1-25-85	Revised Quantities for Item No. 602.0600 Per C.O. No. 1.
12-31-84	Revised Quantities for Item Nos 206,5000, 206,8000, 602.0600, & 611.0100 Per Addendum No. 1.
DATE	REVISION
STATE OF HAWAII DEPARTMENT OF TRANSPORTATION LAND TRANSPORTATION FACILITIES DIVISION INDEX TO DRAWINGS & ESTIMATED QUANTITIES HANAMAULU VIADUCT HANAMAULU-AHUKINI CUTOFF ROAD Ahukini Road to Kauai Hardwoods PROJECT NO. F-051-1(4)	
SCALE: NONE DATE: SEPT., 1984 SHEET NO. 5-1 OF 541 SHEETS

HANAMAULU VIADUCT
HANAMAULU-AHUKINI CUTOFF ROAD
Ahukini Road to Kauai Hardwoods
PROJECT NO. F-051-1(4)

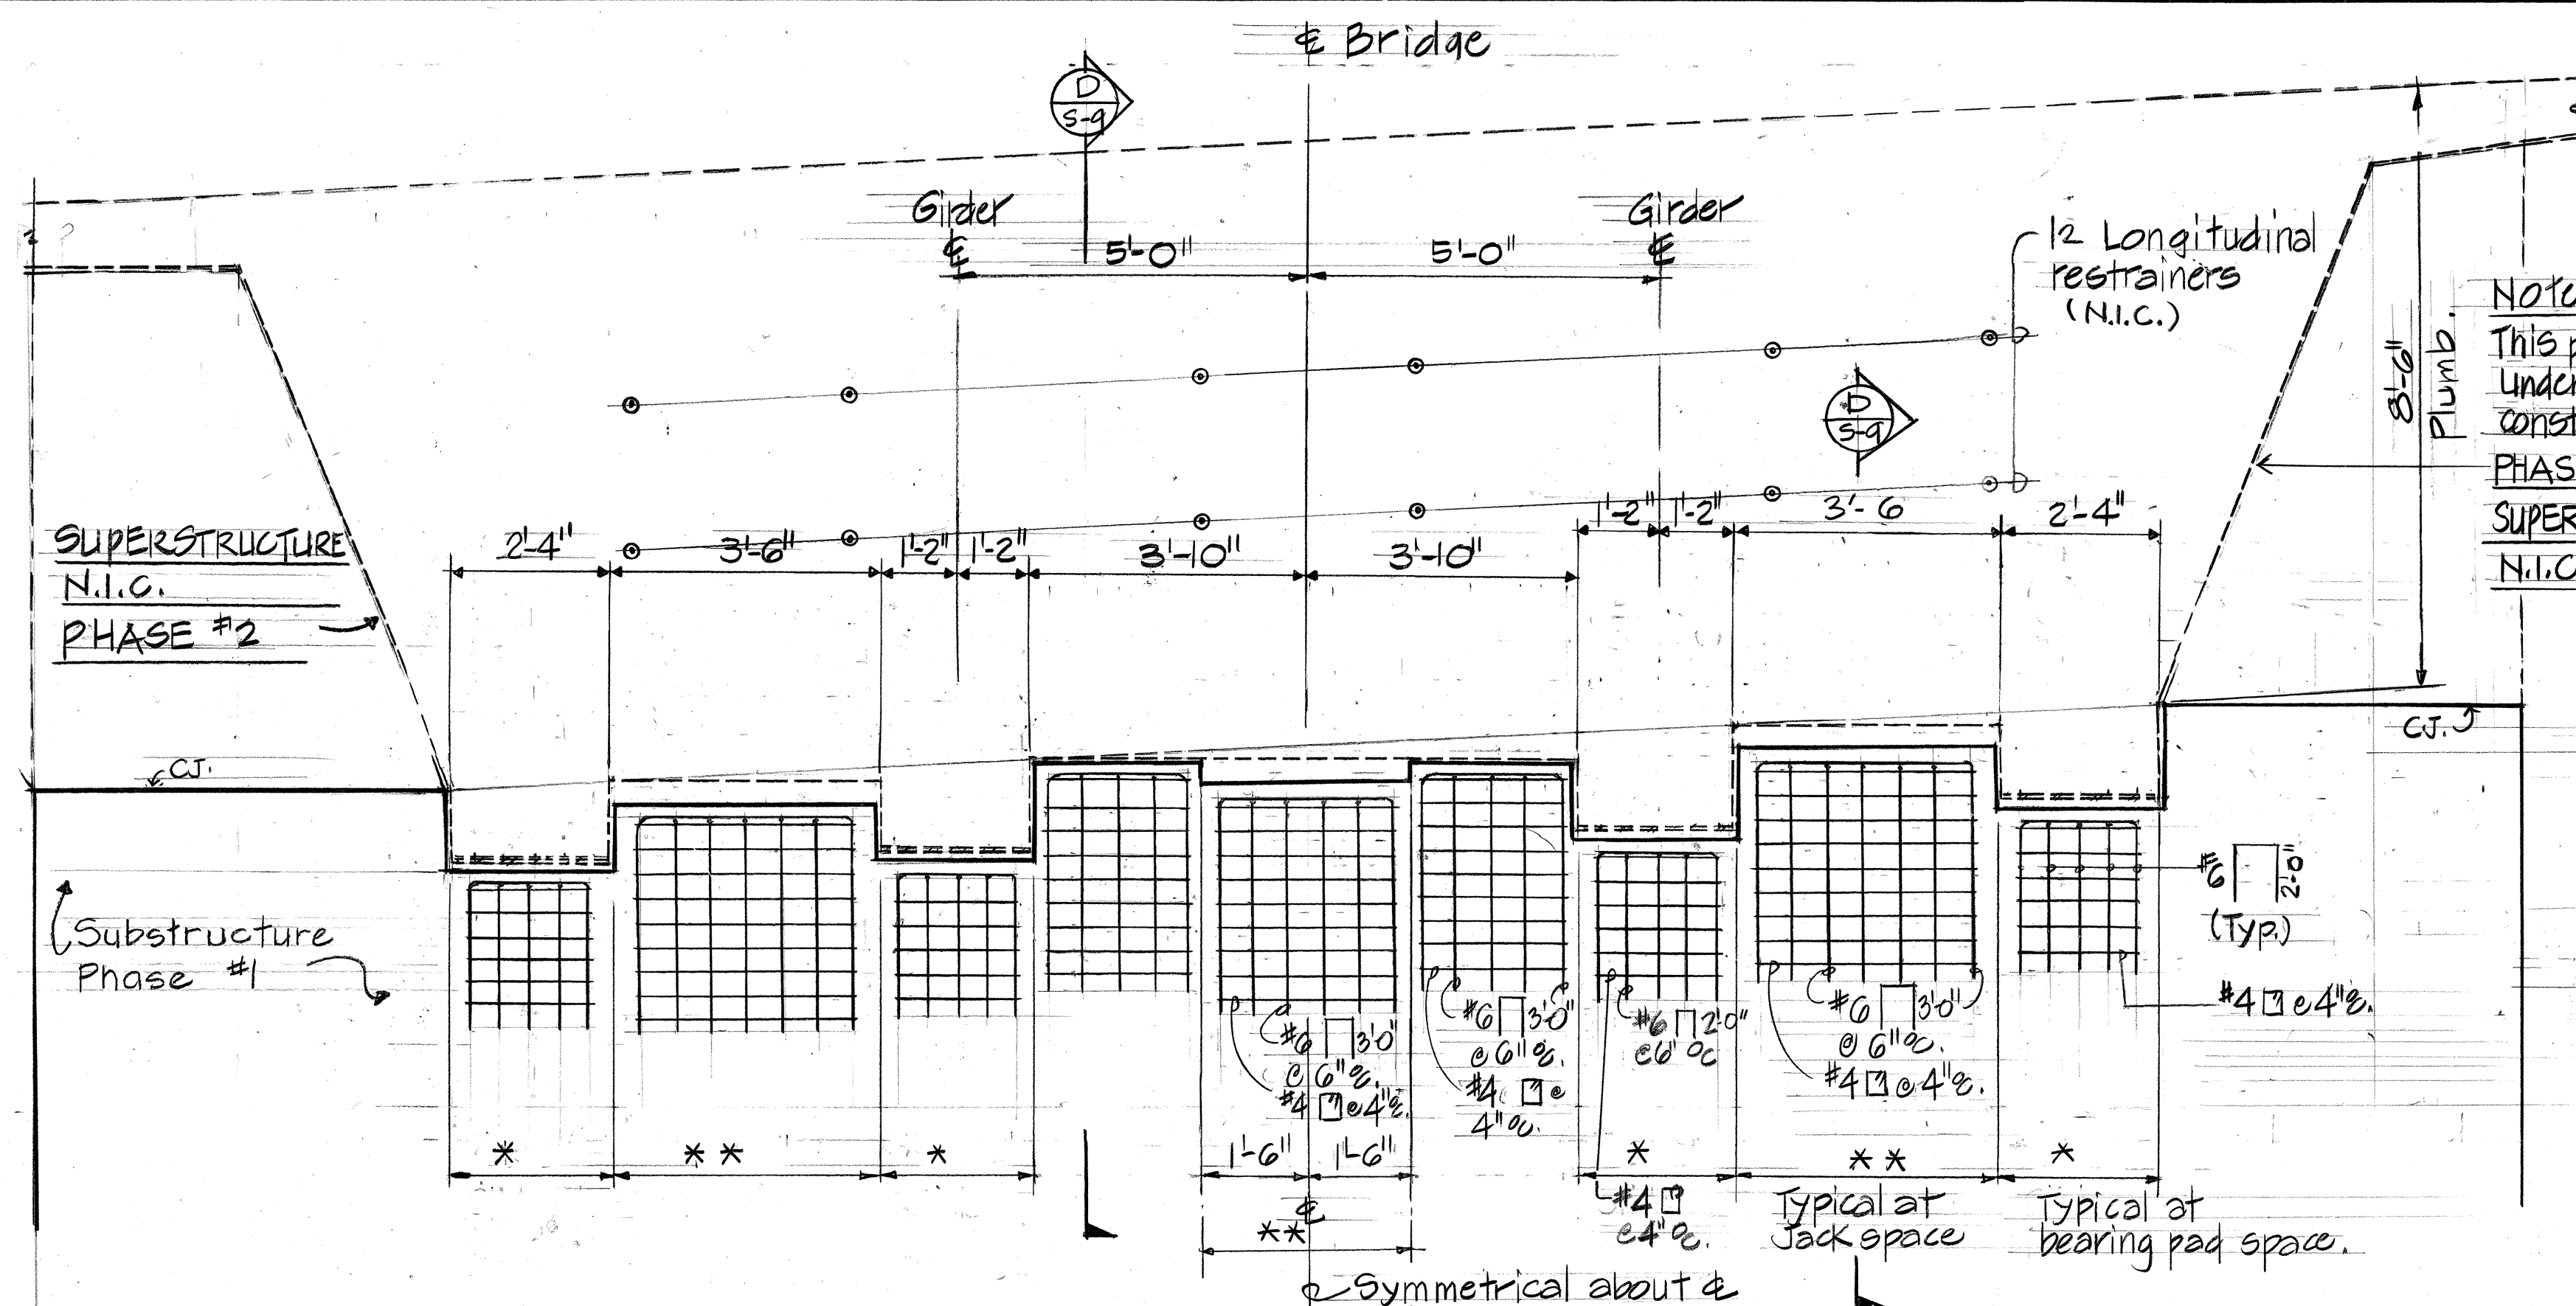
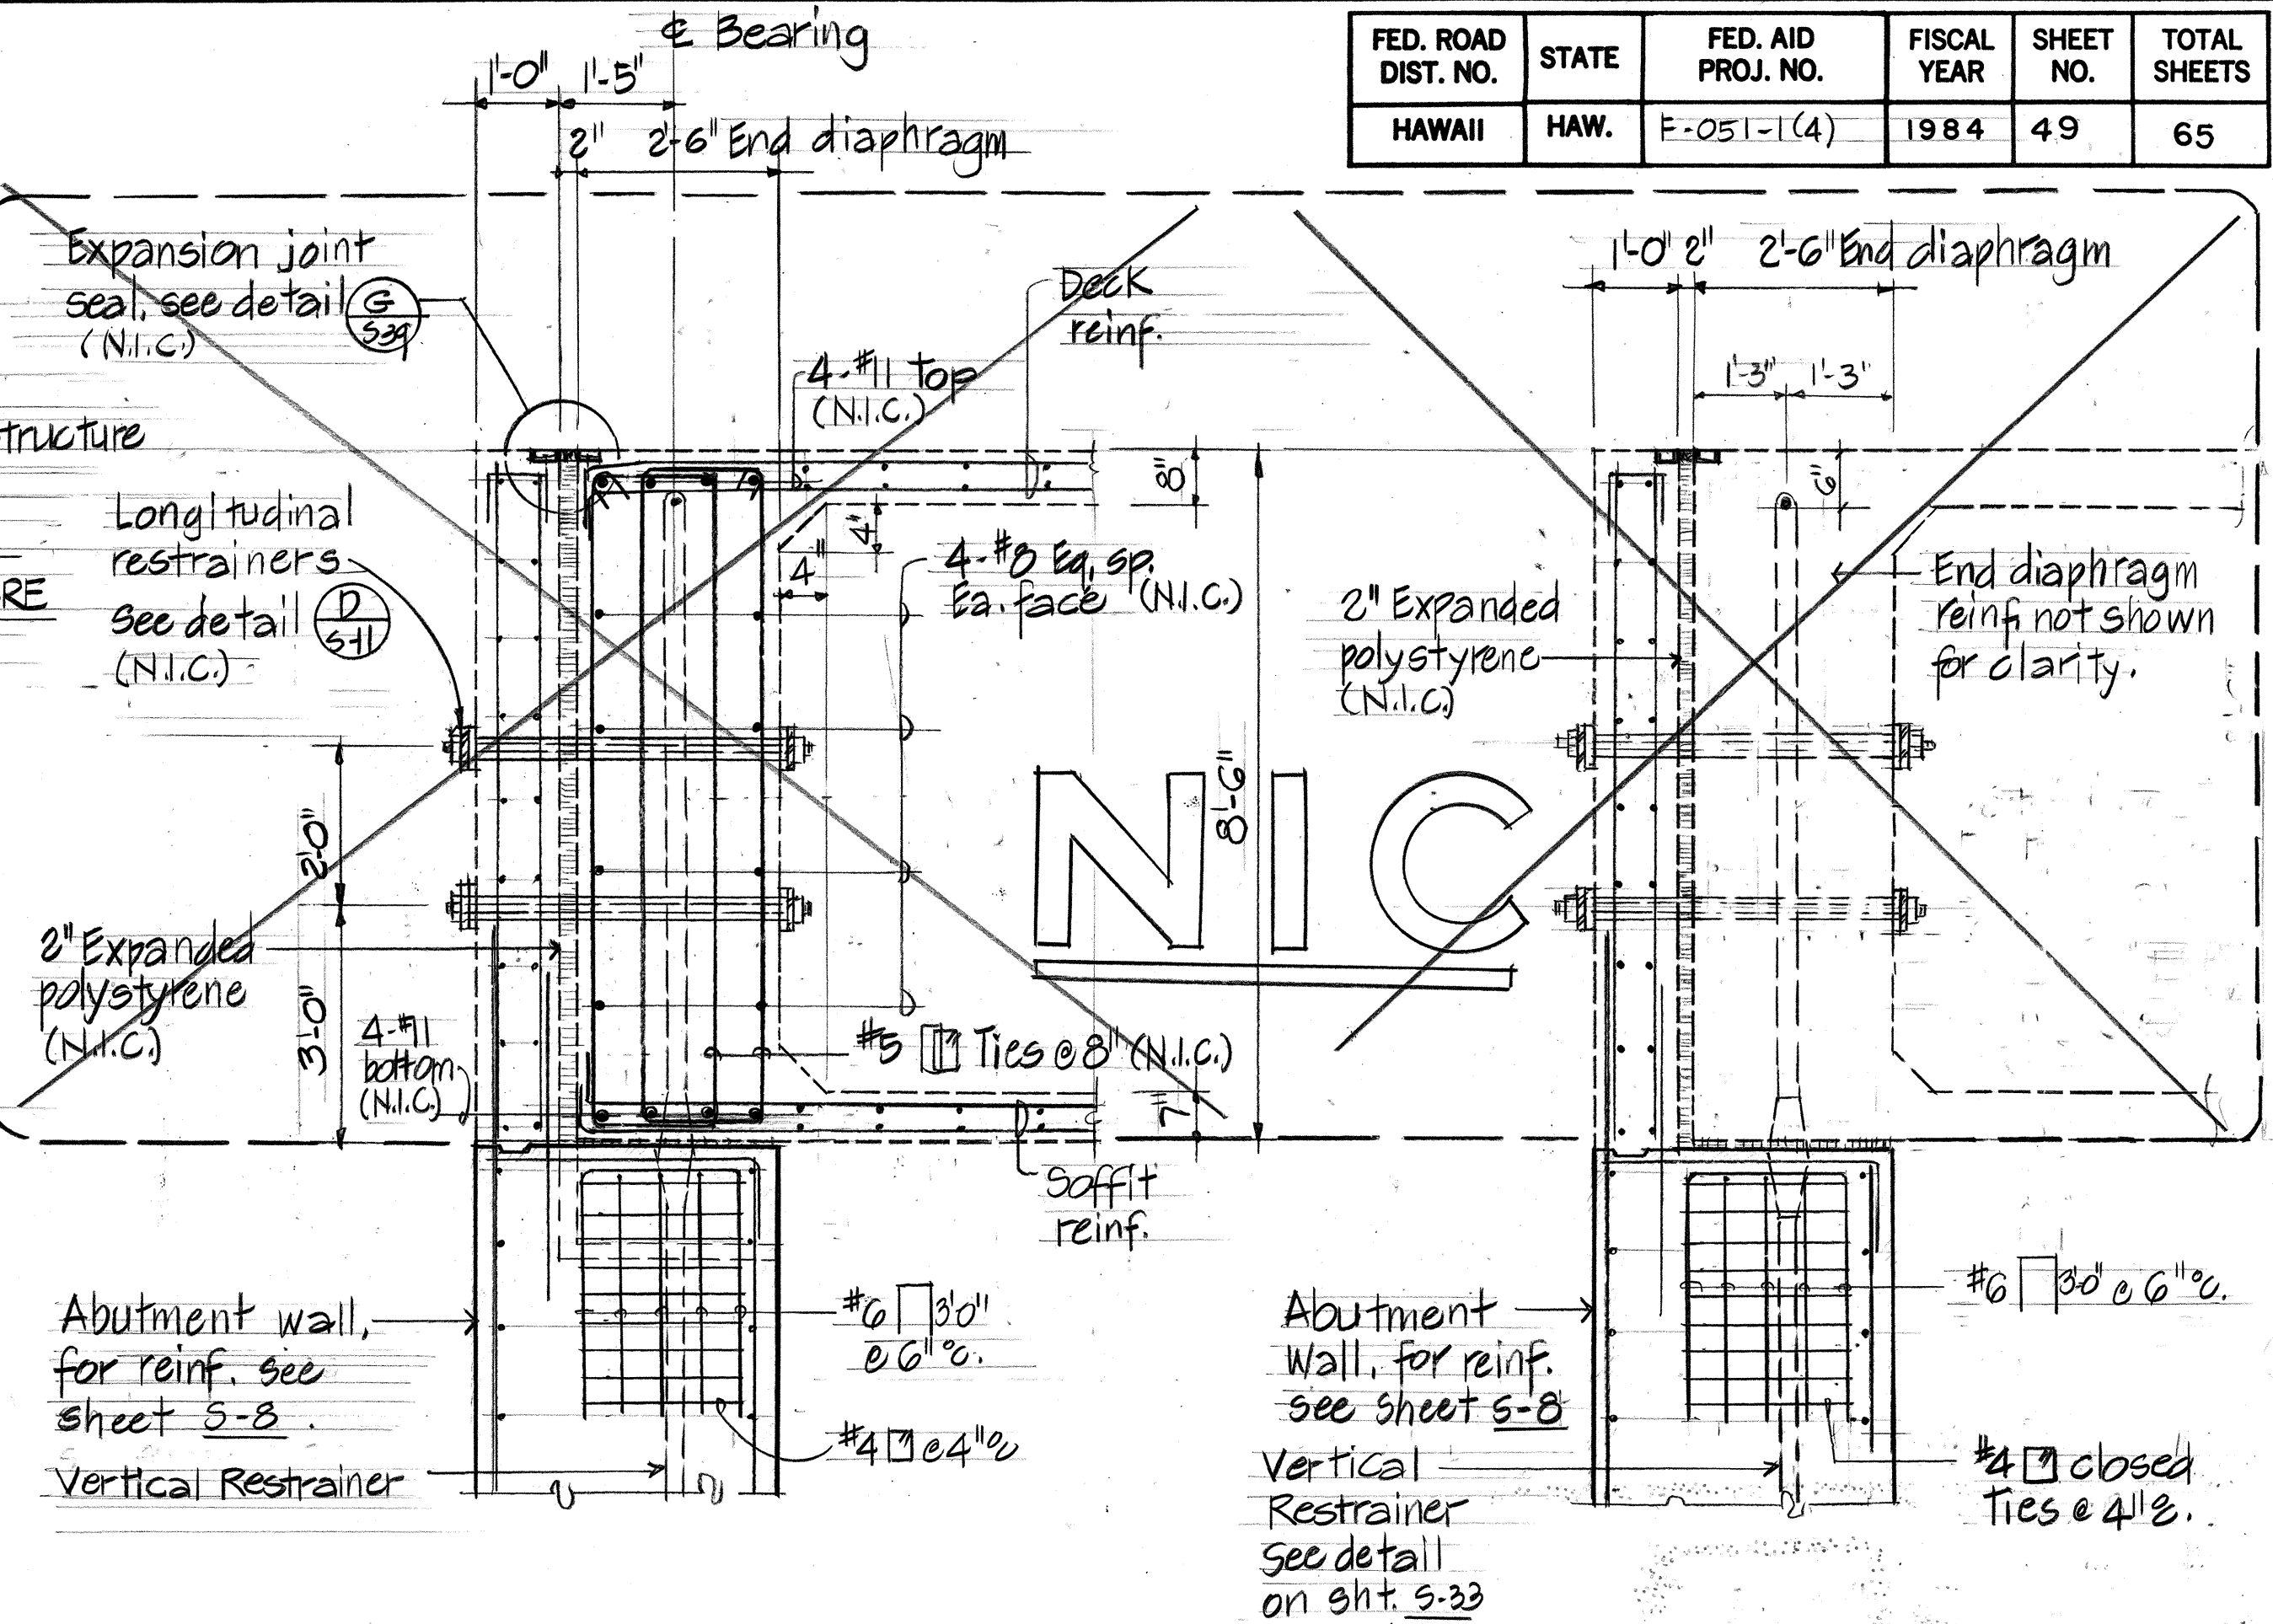
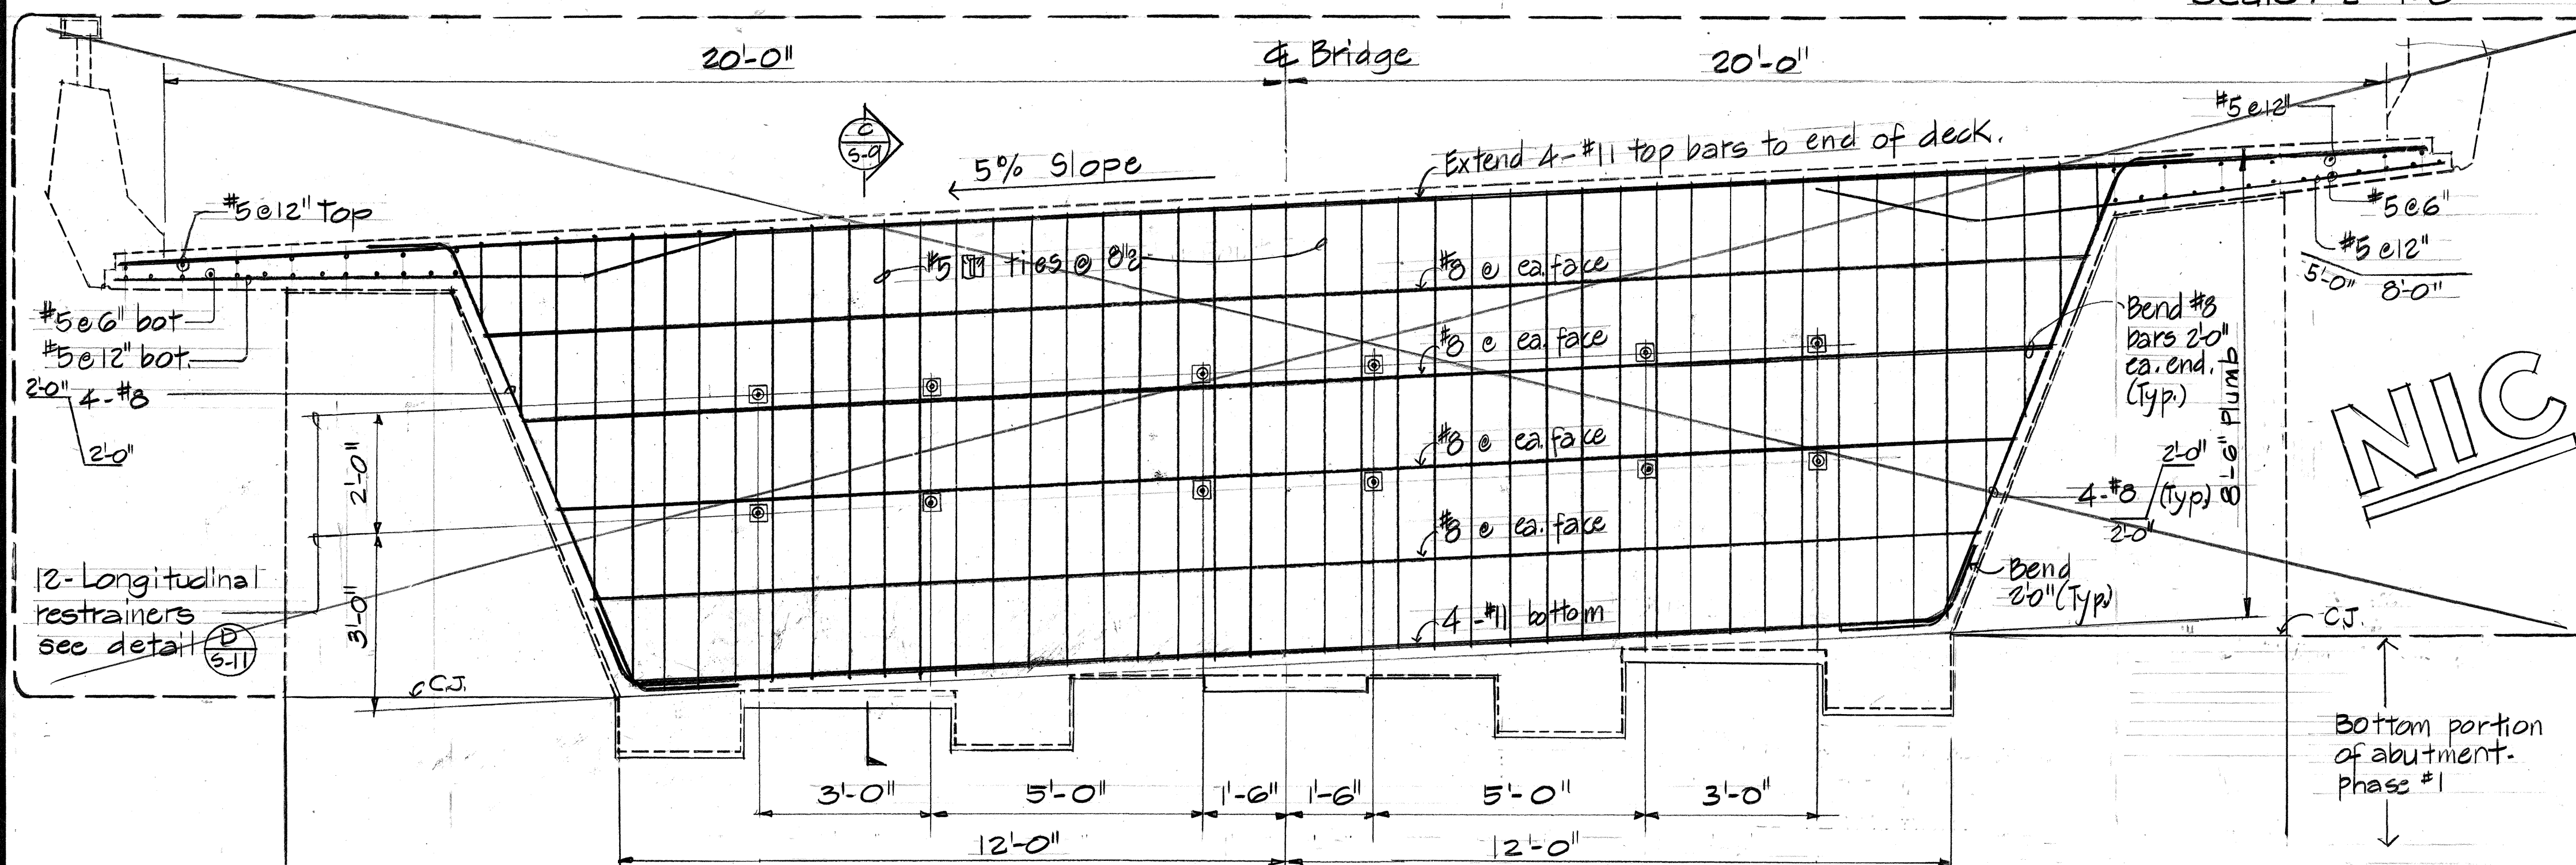
12-31-84	Deleted reference to Sheet 5-11 on Detail (B) Per Addendum No. 1.
DATE	REVISION
STATE OF HAWAII DEPARTMENT OF TRANSPORTATION HIGHWAYS DIVISION ABUTMENT ELEVATIONS AND SECTIONS HANAMAULU VIADUCT HANAMAULU-AHUKINI CUTOFF ROAD Ahukini Road to Kauai Hardwoods PROJECT NO. F-051-1(4)	
SCALE: AS SHOWN DATE: SEPT. 1984 SHEET No. 5-9 OF 5-41 SHEETS
